No.: 06 TS – 10
May 8, 2006

SUBJECT: **MBE 4000 EGR Engine Oil Leak**

Figure 1 - Location of Cup Plugs

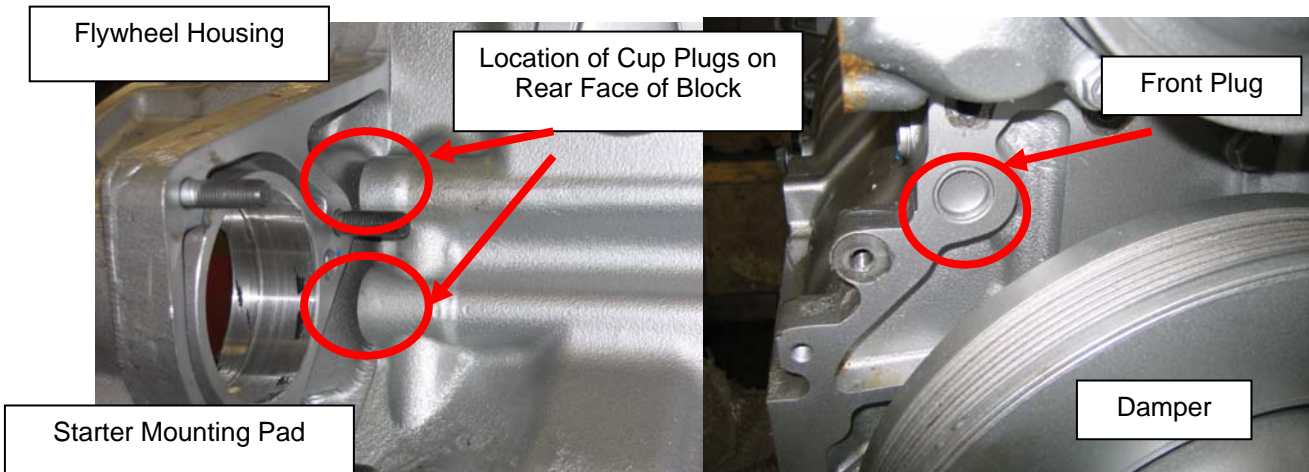
Missing or leaking oil gallery cup plug. There are two cup plugs at the right rear face of the engine block behind the starter and flywheel housing. A third cup plug is on the right front face of the engine block near the damper. See Figure 1 below for the location of the three cup plugs.

Figure 2 – Bracket And Epoxy Installed

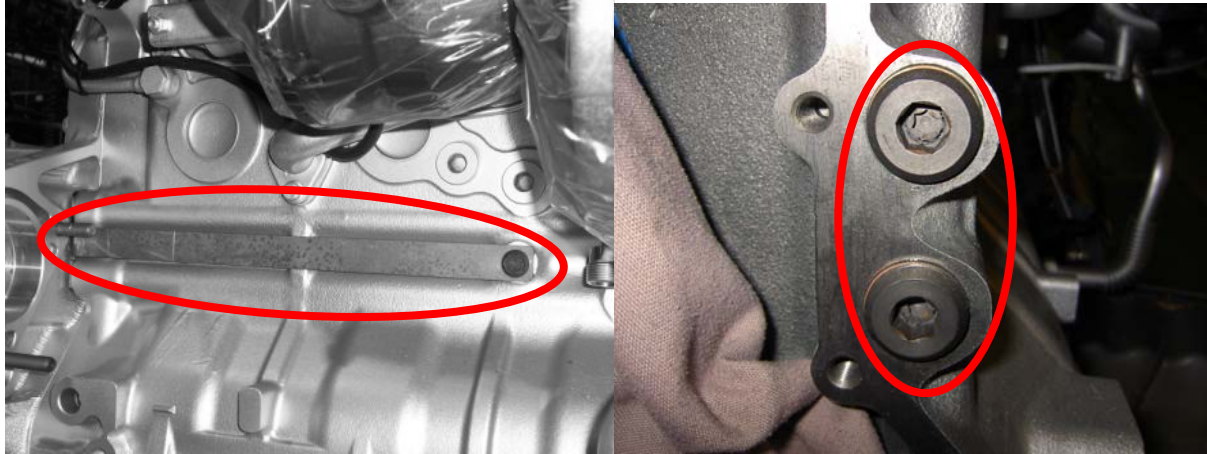
- A bracket and epoxy kit has been developed to retain and seal the two rear cup plugs. See Figure 2. No bracket kit is needed for the front cup plug since the oil pressure is much lower than the two rear cup plugs.

- Install the bracket and epoxy kit on all engines that do not already have it.
- A threaded plug kit was developed to repair engines that suffer a rear cup plug failure. See Figure 3.
